RHODE ISLAND DEPARTMENT OF TRANSPORTATION

RHODE ISLAND CONTRACT NO.2013-CH-050

South Main Street/North Main Street ADA Accessibility Improvements

NOTICE TO PROSPECTIVE BIDDERS

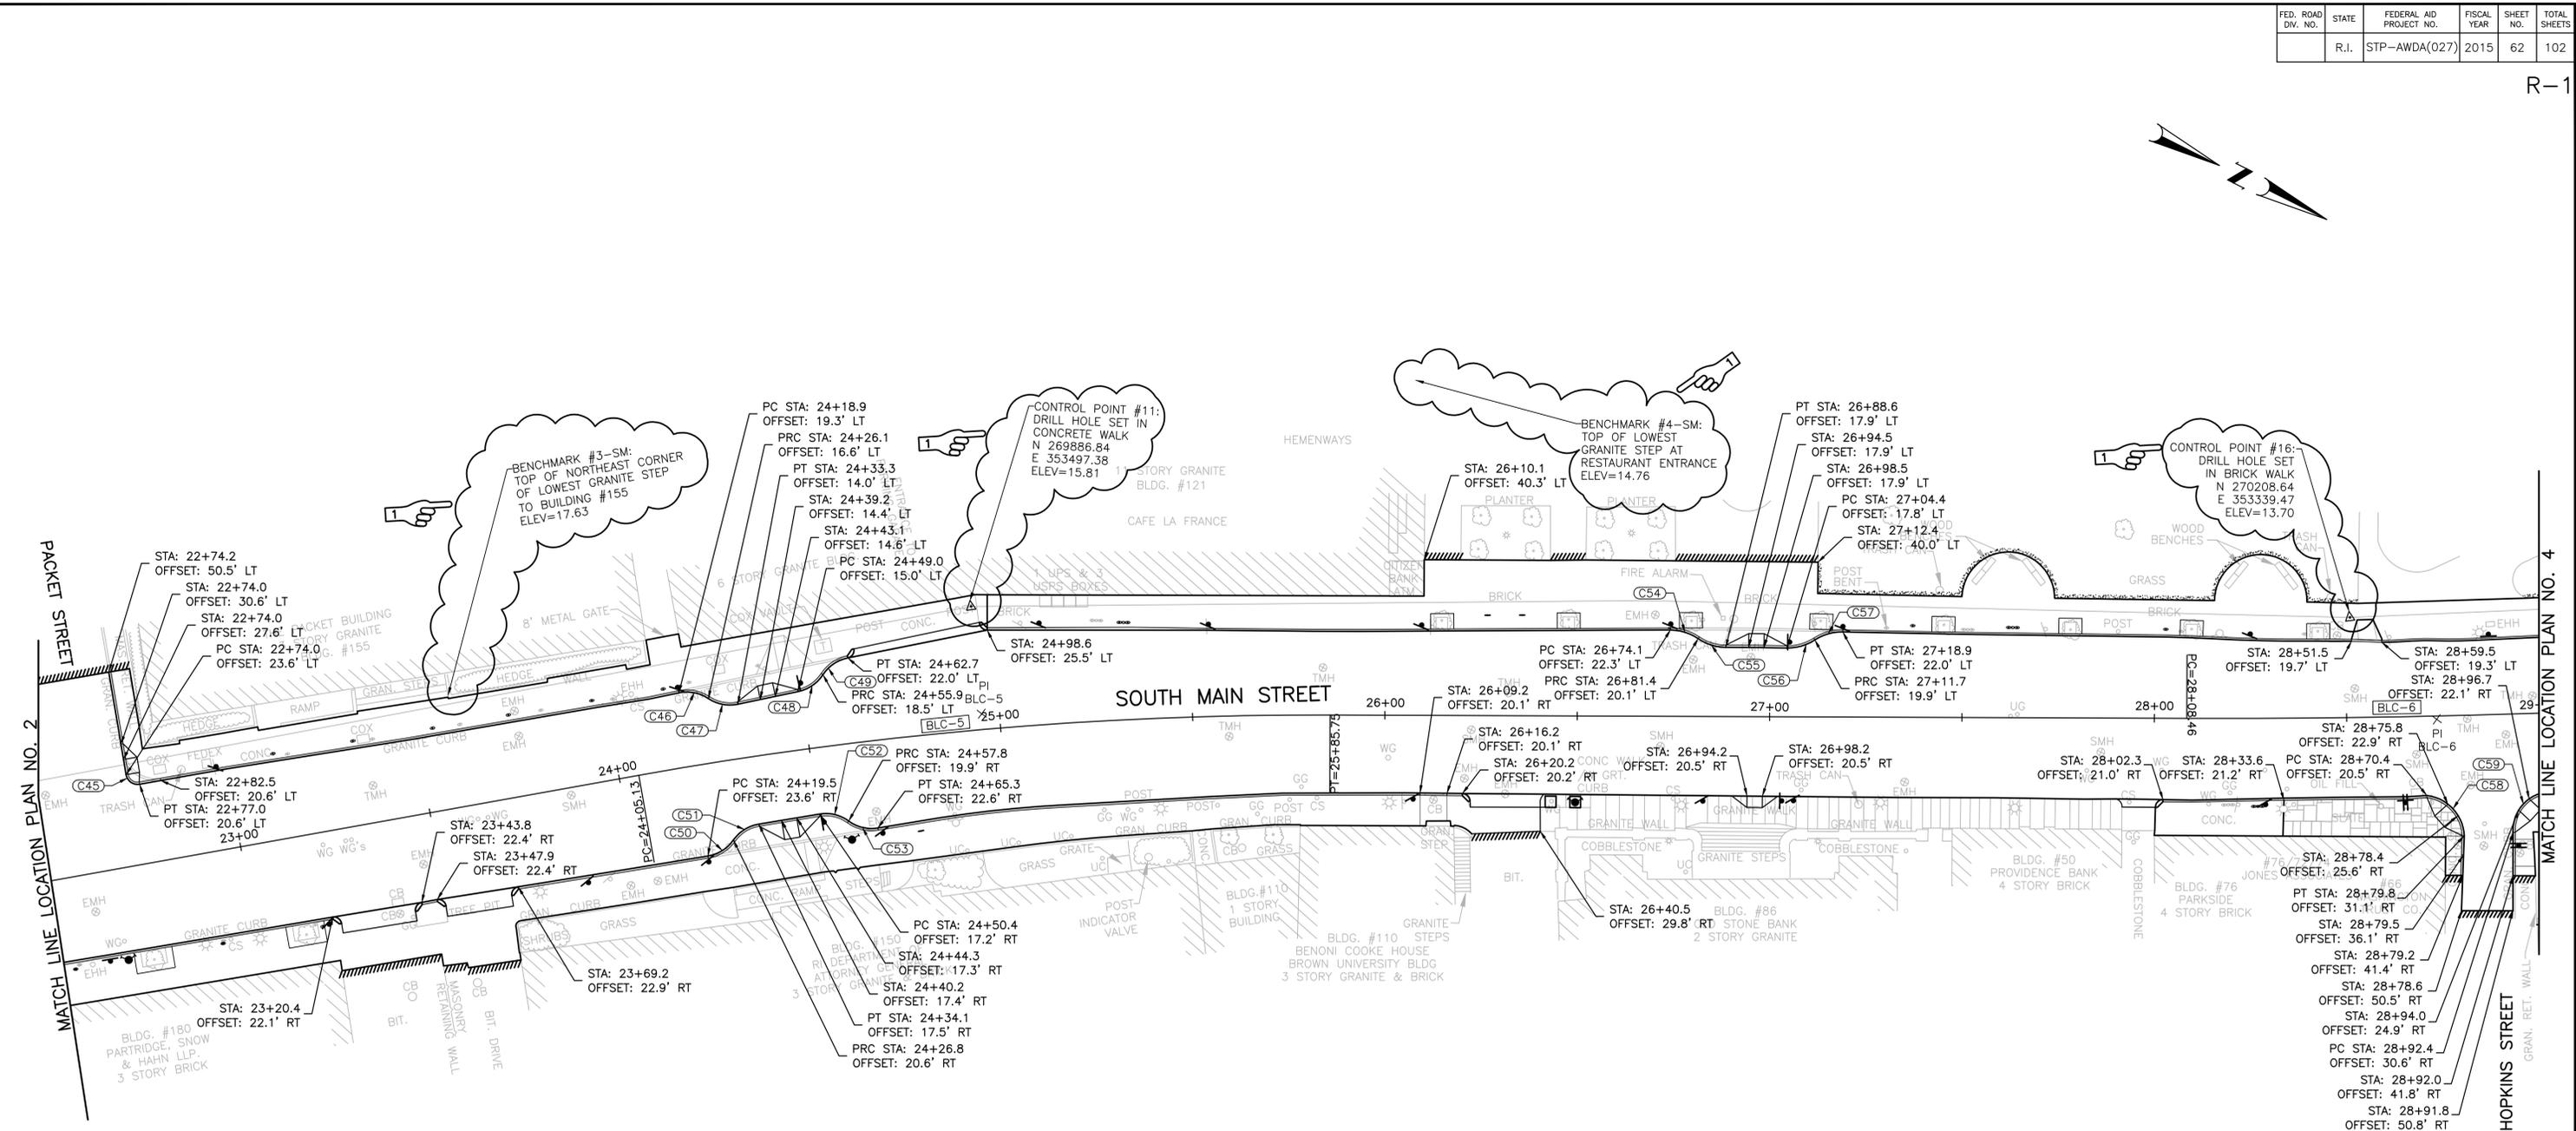
1. SHEET NO. 60 - LOCATION PLAN NO. 1
Delete Sheet No. 60 - Location Plan No. 1 in its entirety and replace it with revised Sheet No. 60 - Location Plan No. 1 (R-1) attached to this Addendum No. 1. Control points and benchmarks have been added.

PVC VENT DETAIL (VNT)
(NOT TO SCALE)

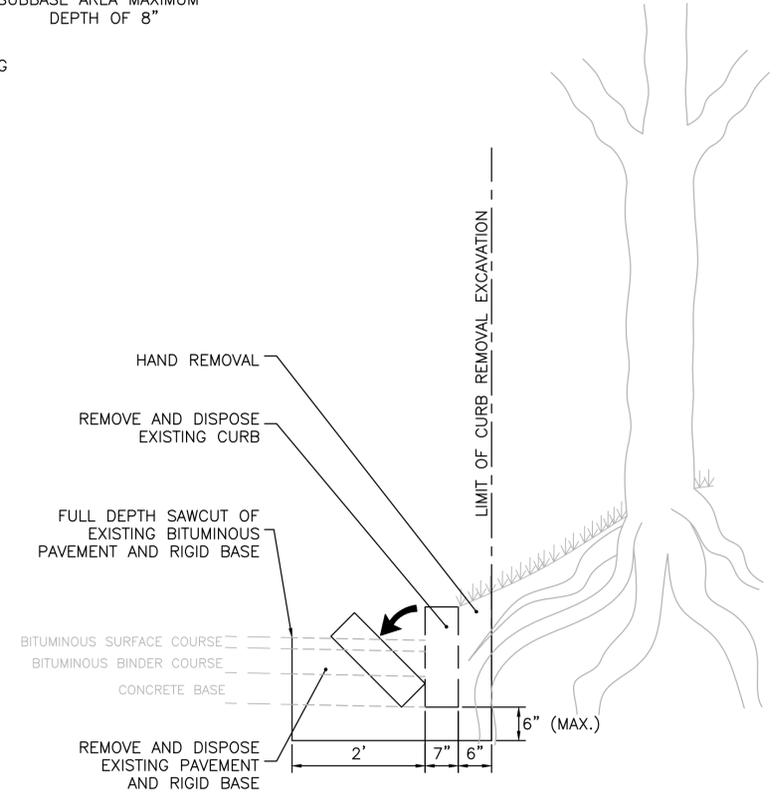
Delete Sheet No. 81 - Landscape Details Sheet No. 1 in its entirety and replace it with revised Sheet No. 81 - Landscape Details Sheet No. 1 (R-1) attached to this Addendum No. 1. The PVC Vent Detail has been revised.

PROVIDENCE STANDARD 7" GRANITE CURB RAMP TRANSITION CURB (7.3.3M)
(NOT TO SCALE)

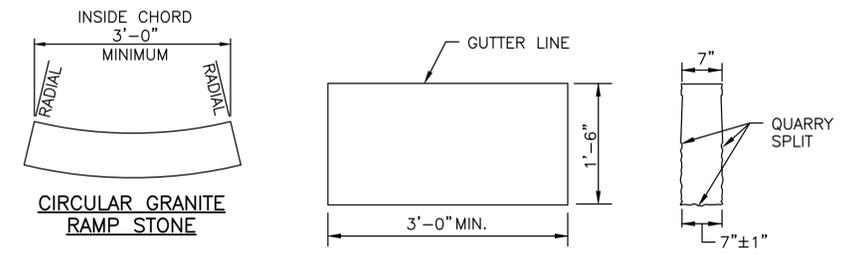
Delete Sheet No. 86 - Details Sheet No. 1 in its entirety and replace it with revised Sheet No. 86 - Details Sheet No. 1 (R-1) attached to this Addendum No. 1. The Providence Standard 7" Granite Curb Ramp Transition Curb detail, the Granite Curb Providence Standard 7" detail, the Providence Standard 7" 3'-0" Granite Transition Curb detail, and the Providence Standard Granite 2'-0" Radius Corner detail have been revised.

PROVIDENCE STANDARD GRANITE INLET STONE. (P-17)
STANDARD P-17
(NOT TO SCALE)

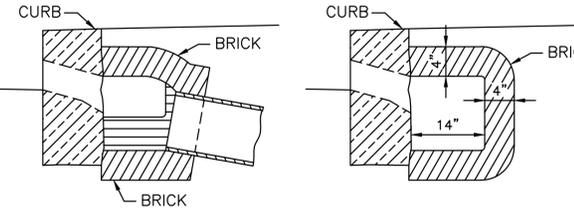
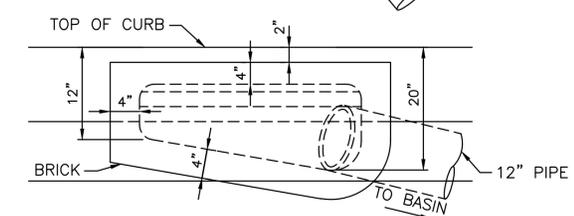
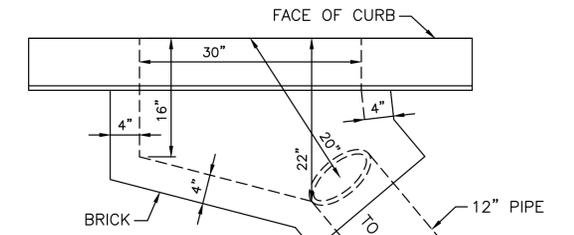
Delete Sheet No. 97 - Details Sheet No. 12 in its entirety and replace it with revised Sheet No. 97 - Details Sheet No. 12 (R-1) attached to this Addendum No. 1. The Providence Standard Granite Inlet Stone, Standard P-17 detail has been revised.
